AGENDA

Lexington Planning Board

952 Waltham Street - Village overlay site plan review

This letter is to advise the Town of Lexington's Planning Board that Apex Companies, LLC (Apex) has reviewed the revised materials submitted for the proposed townhouse-style development project located at 952 Waltham Street. The Applicant's submission includes the following documents:

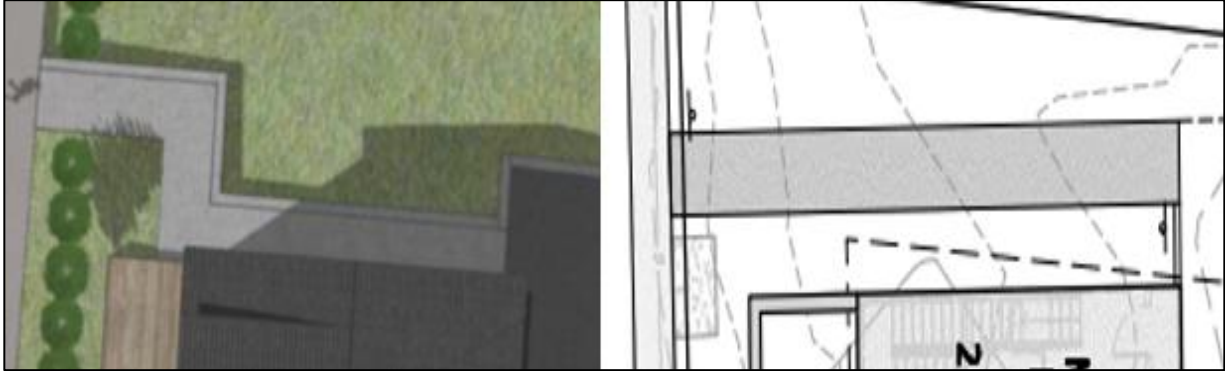
The garages on Units 1 – 3 are significantly taller than the garages on Units 4 – 8. What is the reason for the height difference? Can the garages on Units 1 – 3 be shortened to lower the building height?

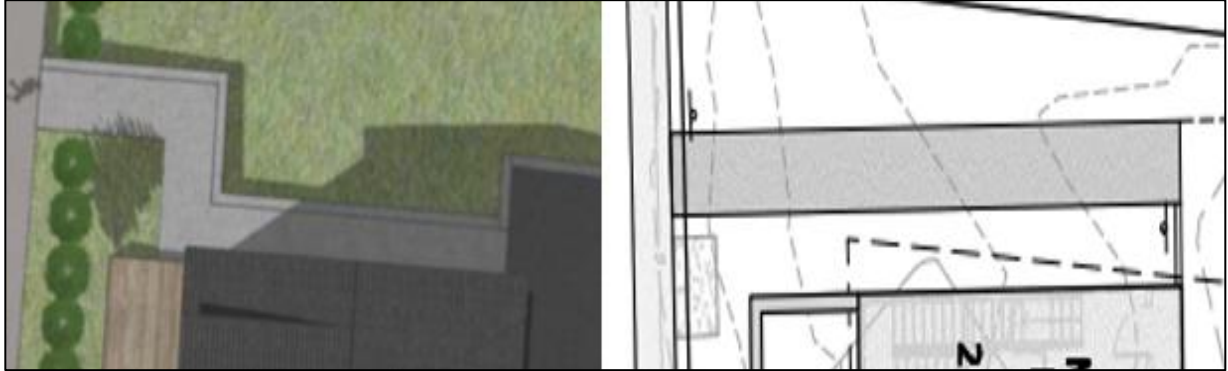
The garages on Units 1 – 3 are significantly taller than the garages on Units 4 – 8. What is the reason for the height difference? Can the garages on Units 1 – 3 be shortened to lower the building height?
